Planning and Zoning Commission AGENDA

Monday, March 09, 2020

STAFF REPORT
KETCHUM PLANNING AND ZONING COMMISSION
REGULAR MEETING OF MARCH 9th, 2020

PROJECT:	4 th & Walnut Avenue Mixed-Use Building
FILE NUMBER:	P 20-024
APPLICATION TYPE:	Pre-Application Design Review
ARCHITECT:	Graham Whipple, Resin Architecture
PROPERTY OWNER:	Walnut & Fourth LLC (Representative: Ryan Kirkham)
REQUEST:	Pre-Application Design Review for the development of a new 27,316 square-foot, two-story mixed-use building
LOCATION:	371 & 391 N Walnut Avenue (Ketchum Townsite: Block 44: Lots 7 & 8)
ZONING:	Retail Core of the Community Core (CC-1)
REVIEWER:	Abby Rivin, Associate Planner

FIRST FLOOR PLAN
SCALE: 3/32" = 1'-0"

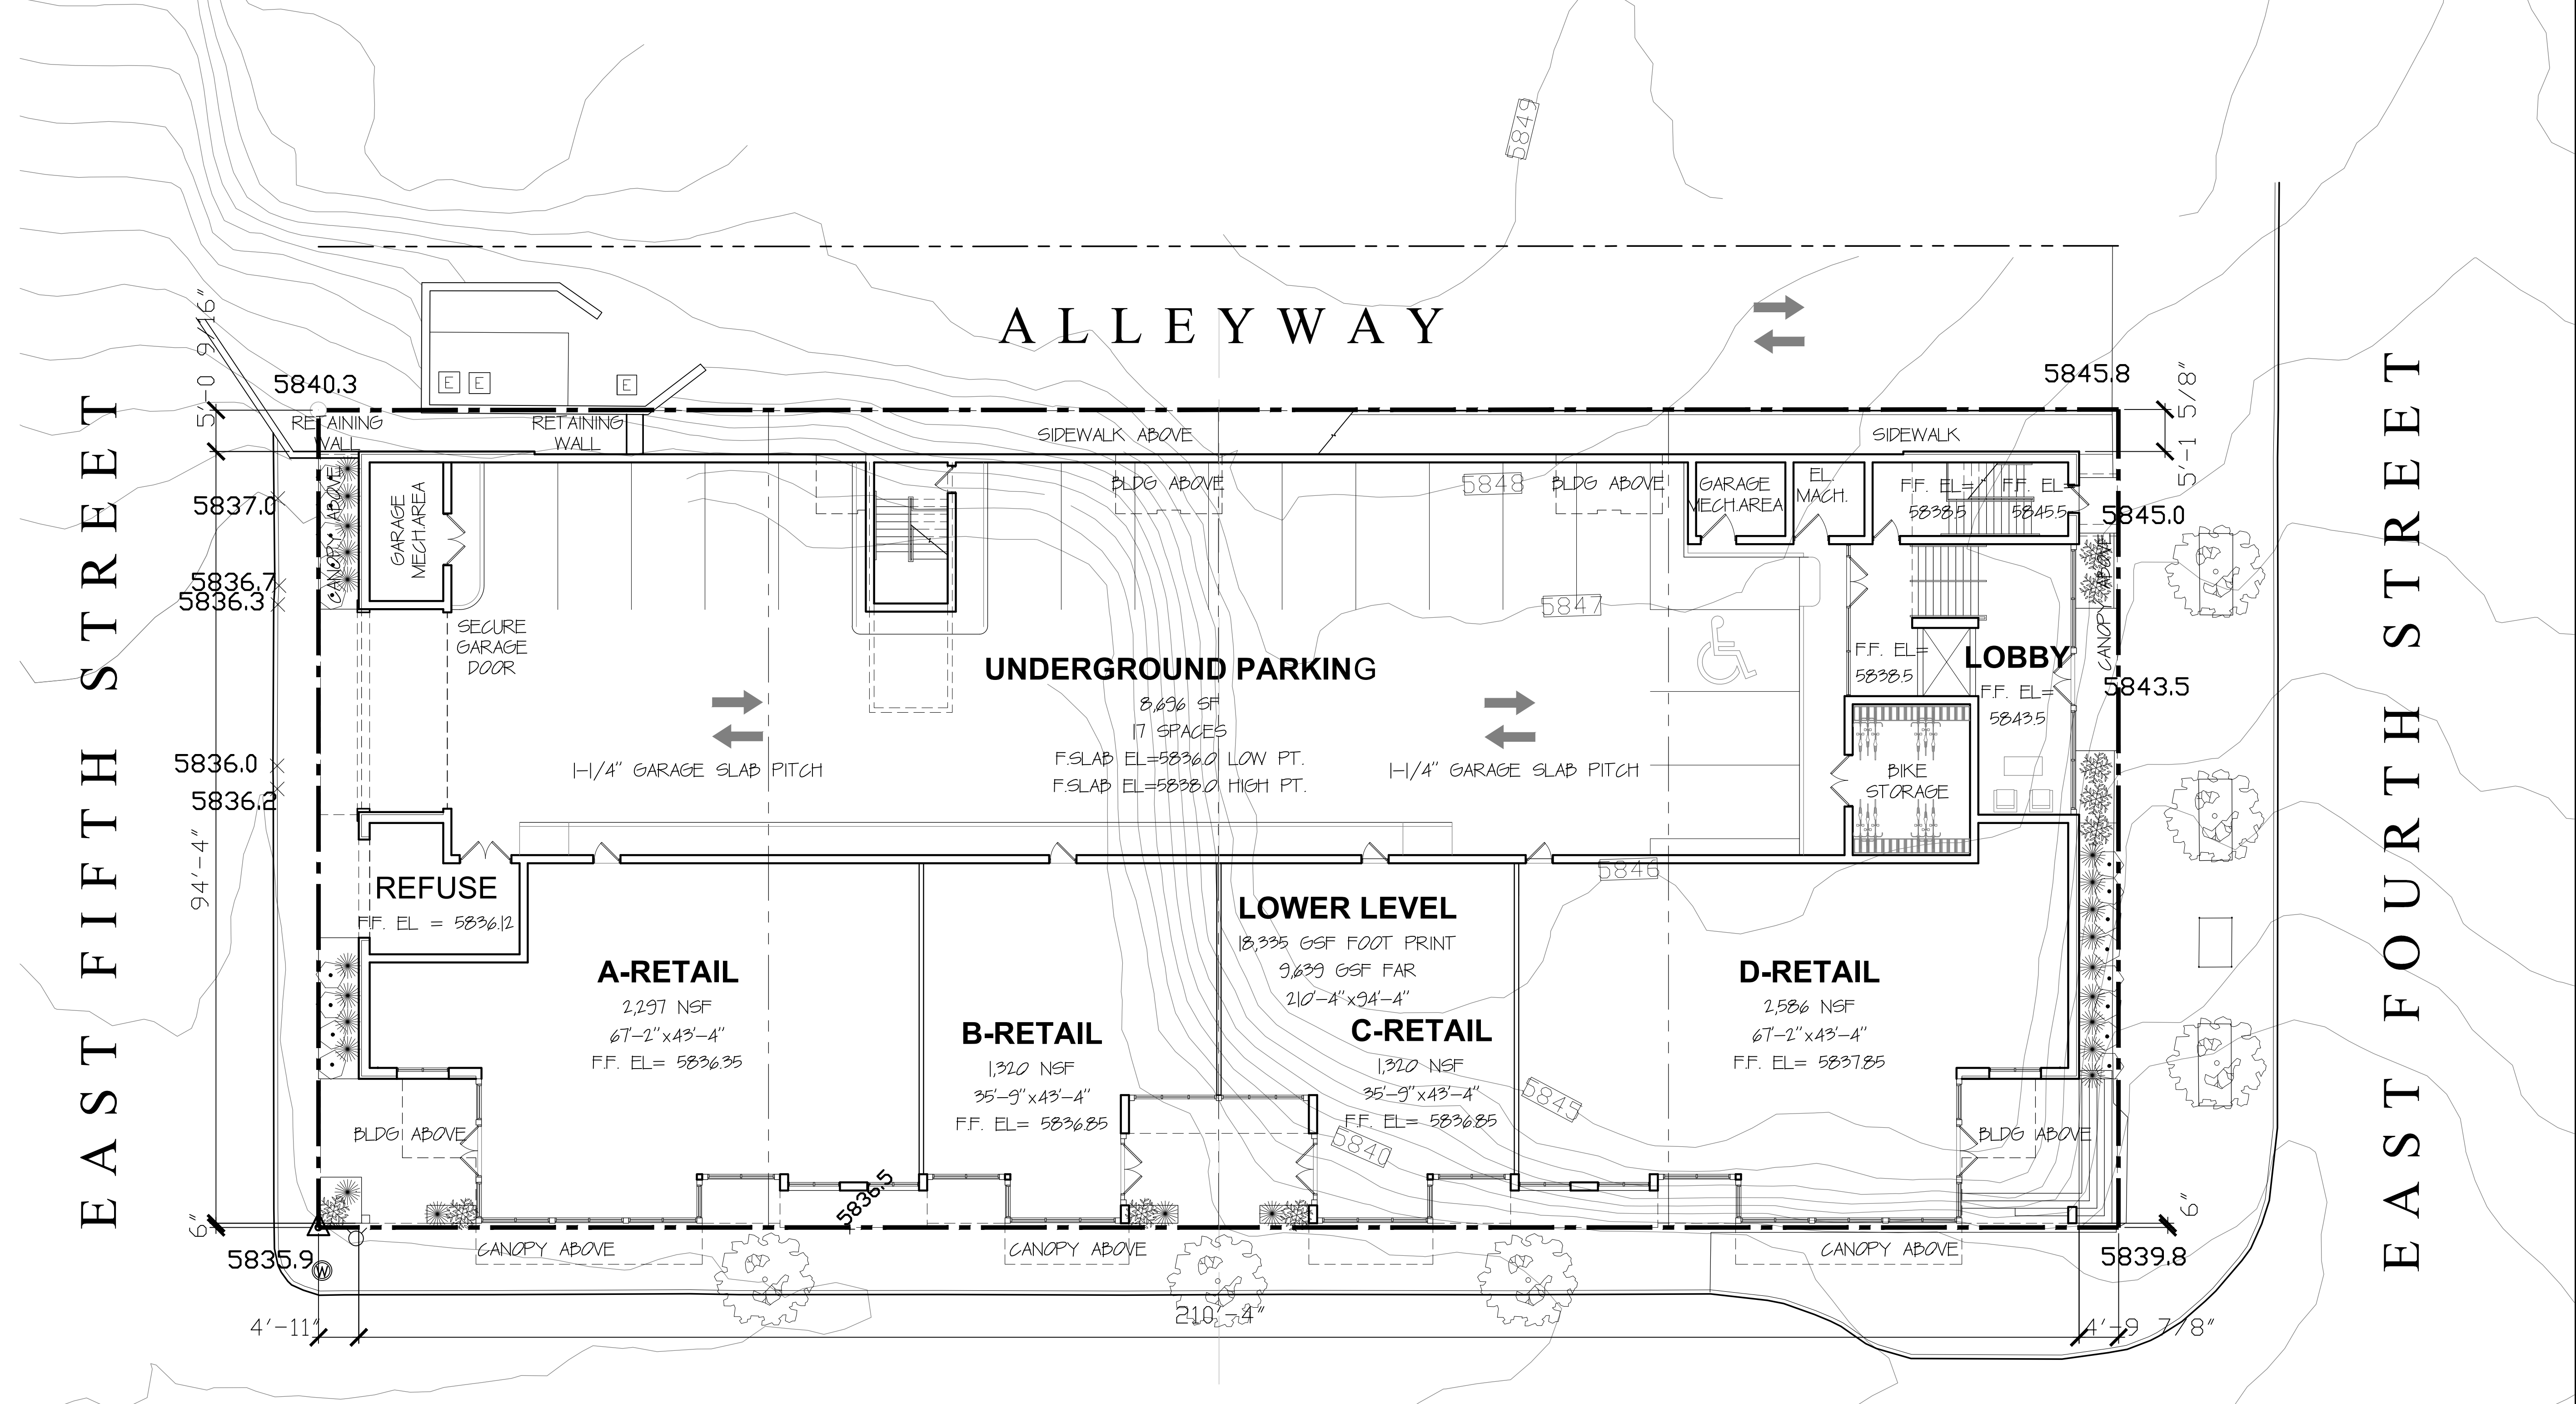
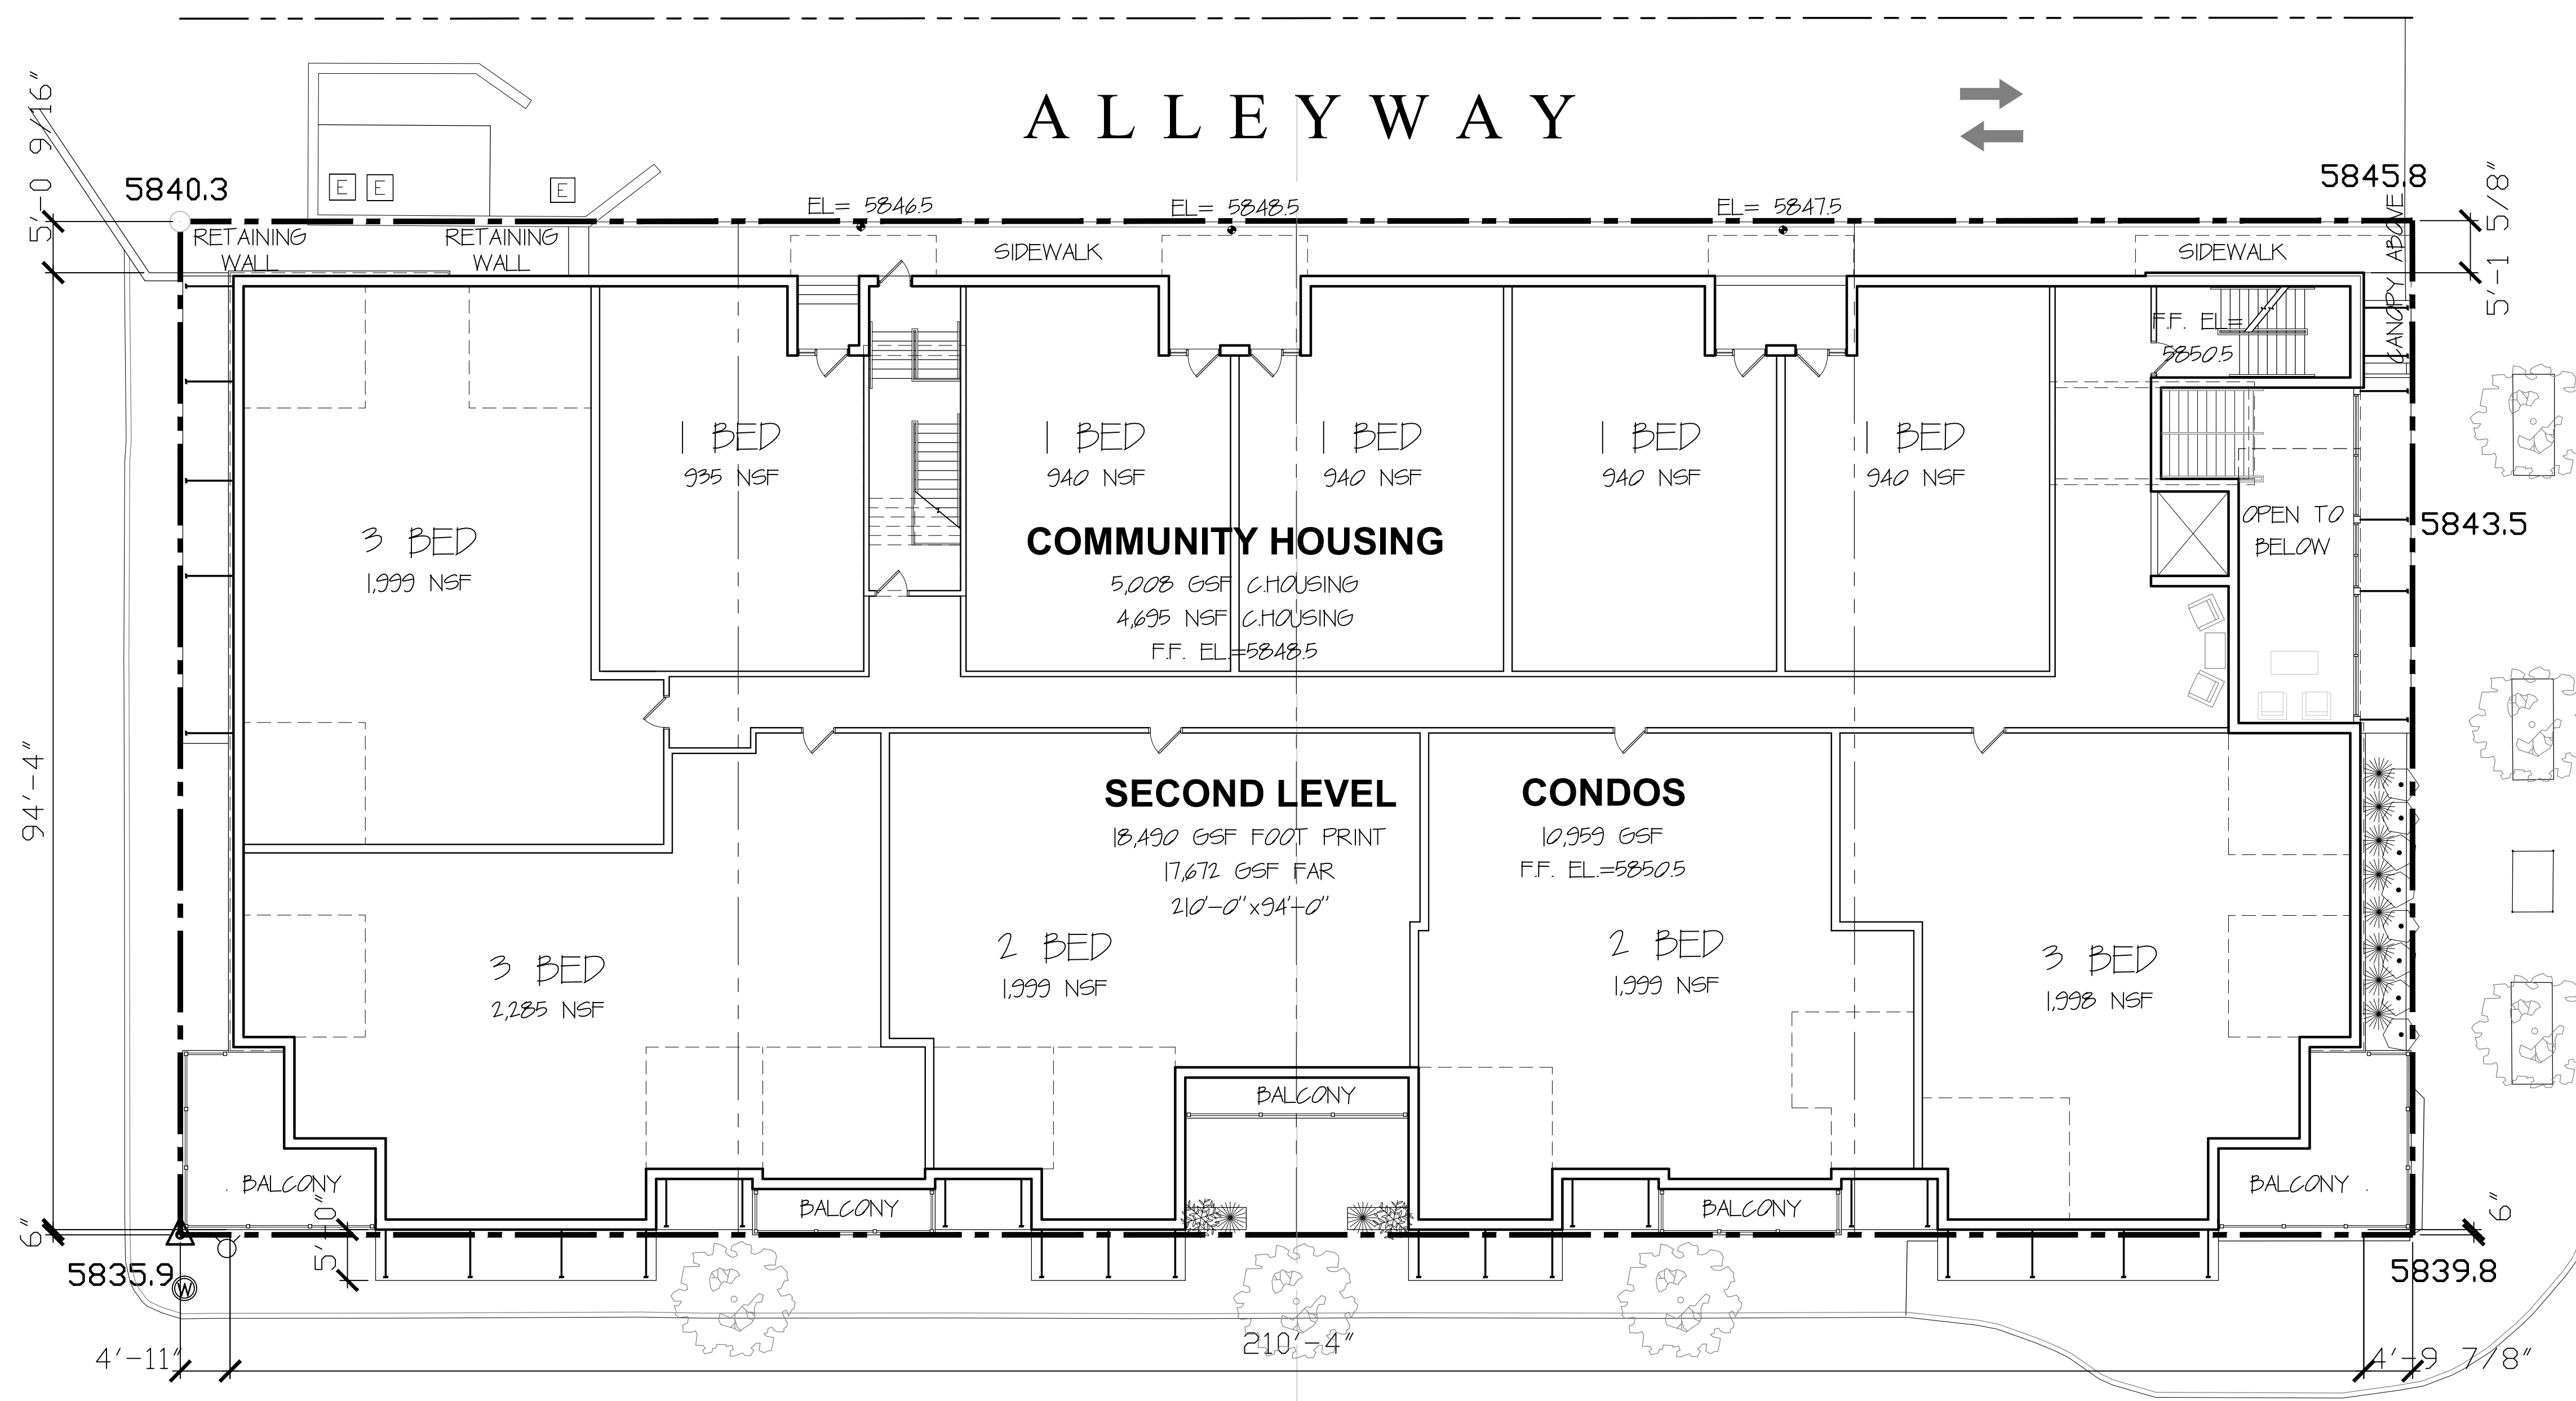
The floor plans on Sheets A1.0, A1.1, A1.2, and A1.3 don't show the location of window or door openings. The elevations indicate residential units with walls comprised entirely of windows. The building's outsides don't match its insides—the exterior of the building doesn't match the residential use proposed within the building. This discrepancy raises a concern that of the preliminary design drawings unrealistically depict the building's appearance.
